SUBJECT: PARCEL 77 AUTO IMPORT TERMINAL
PROJECT NO. ~~201020.01~~101247.01
CONTRACT NO. 070770

ADDENDUM NUMBER 05

PARCEL 77 AUTO IMPORT TERMINAL

C2.3

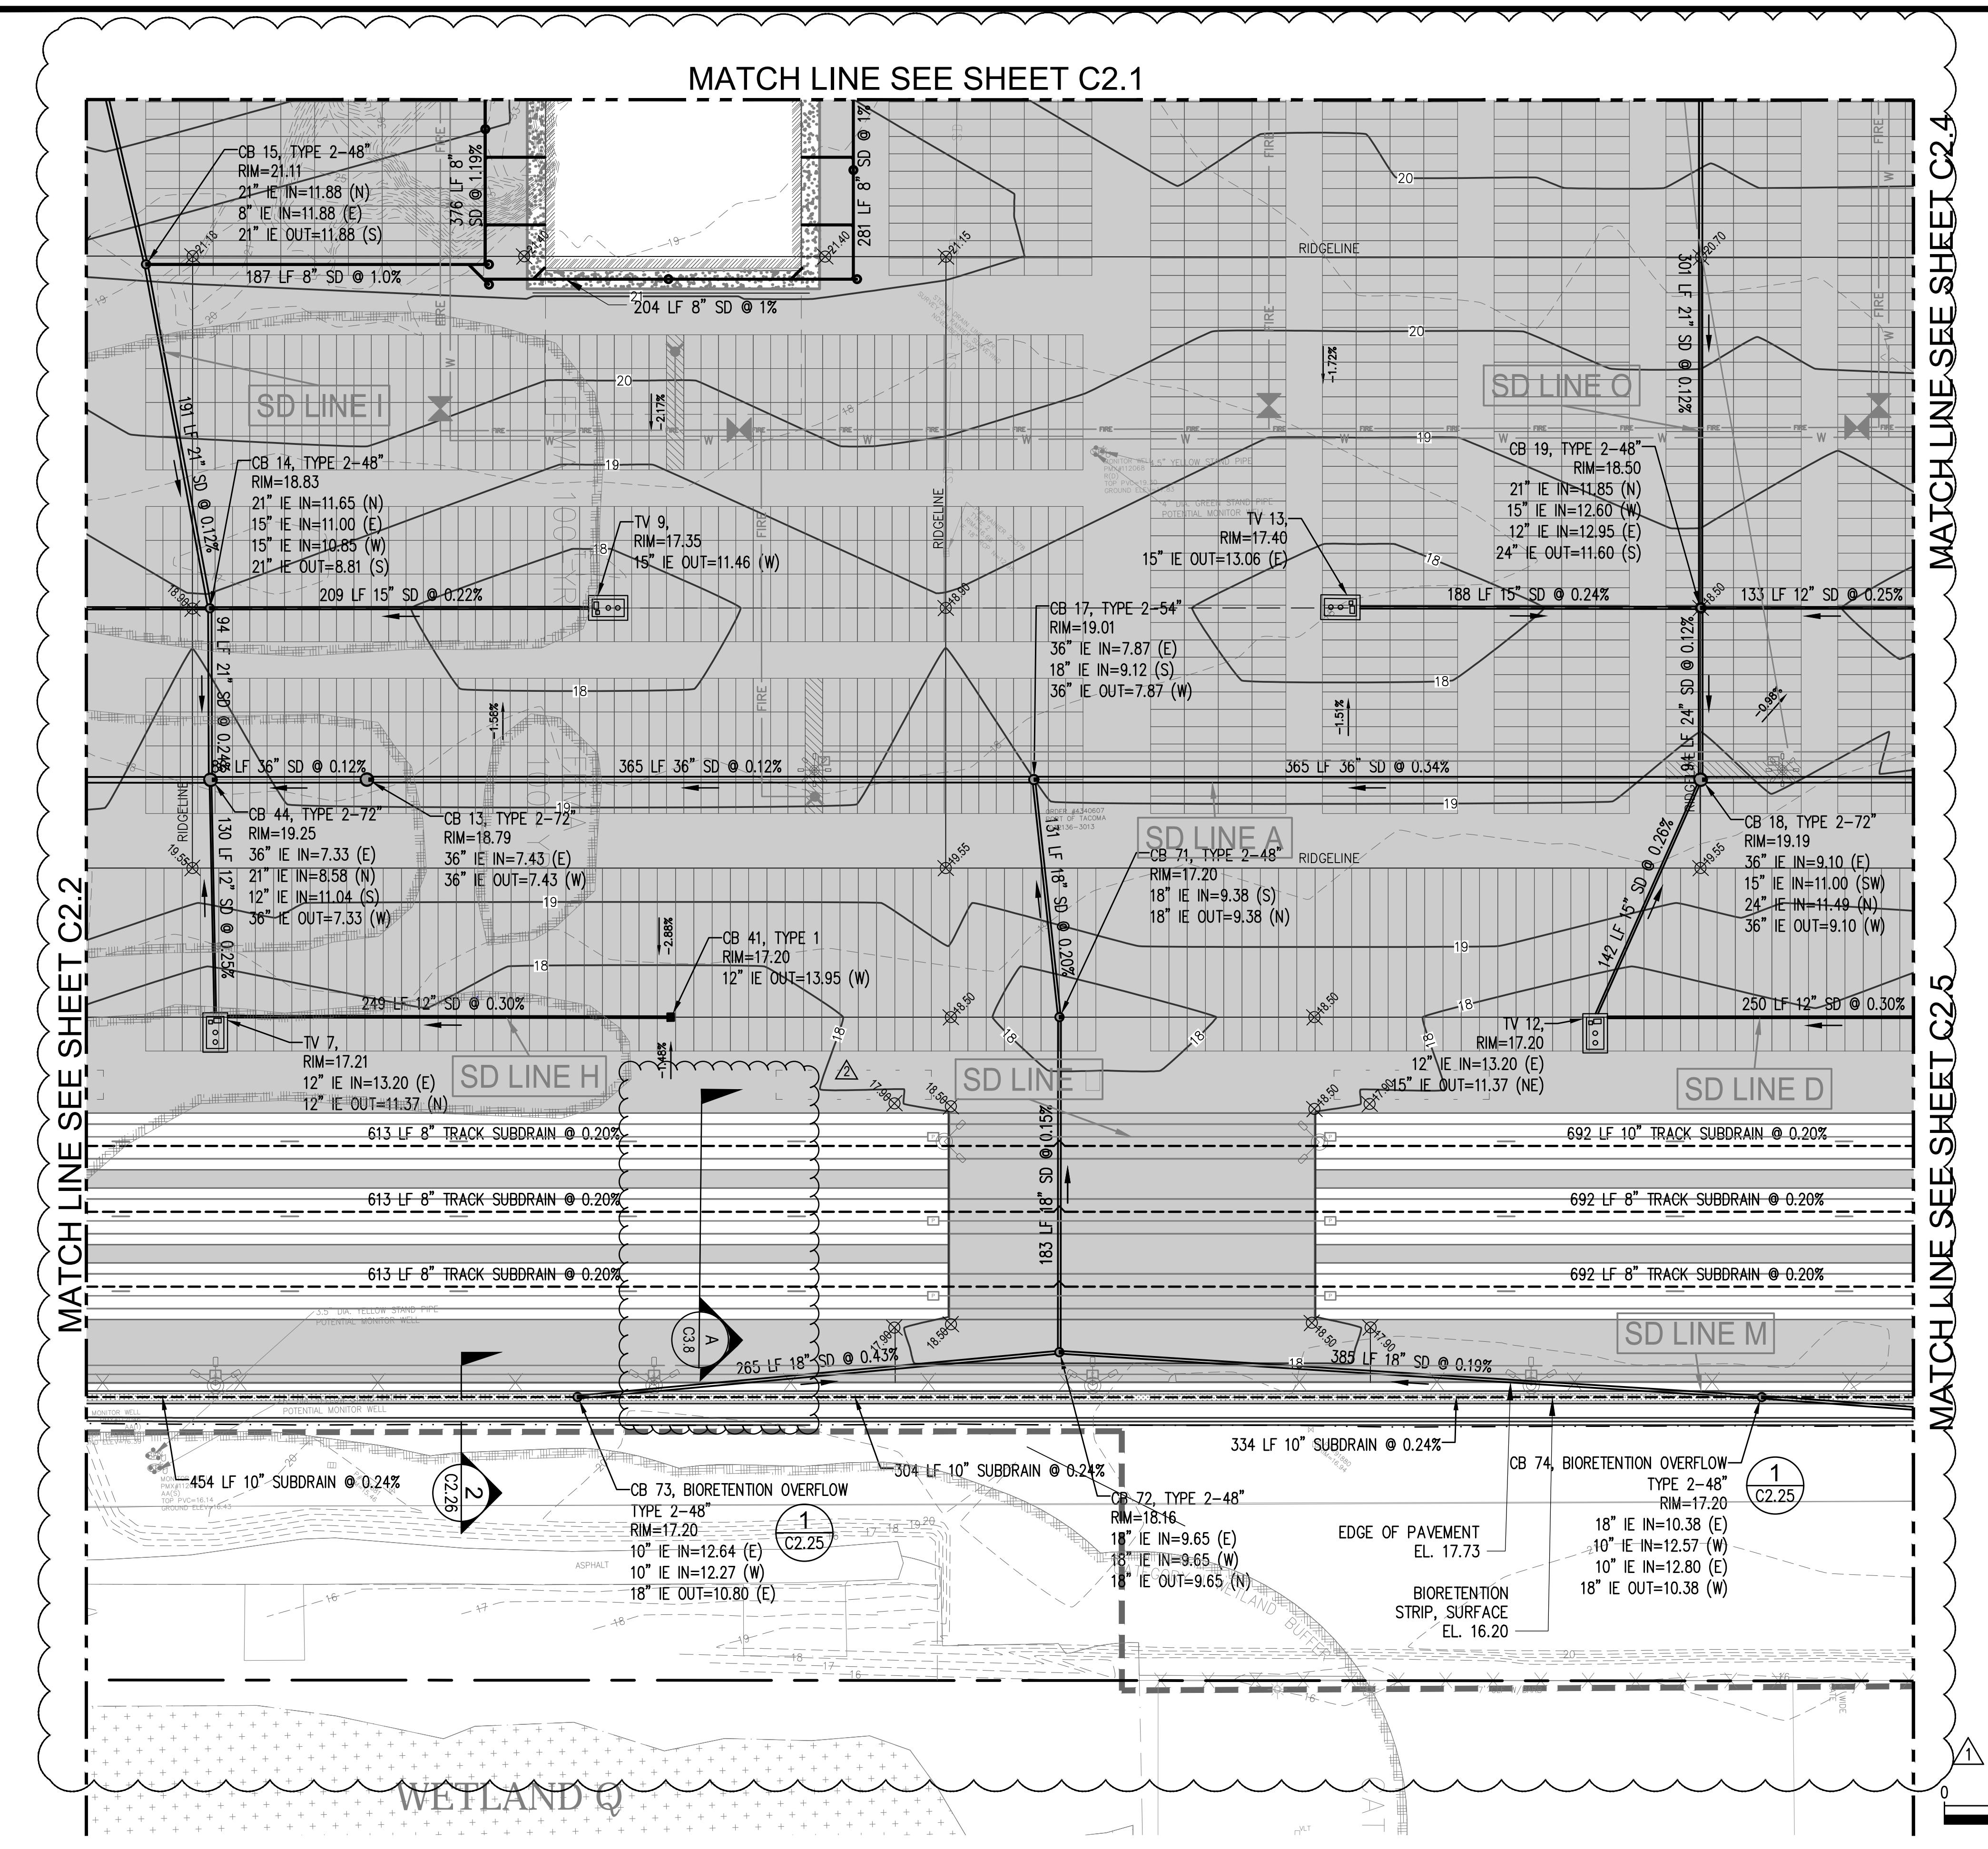
- 1. DELETE AND REPLACE** the issued Plans C2.3, C2.6, and C3.8 with the attached Plans C2.3, C2.6, and C3.8 (Attachment D).
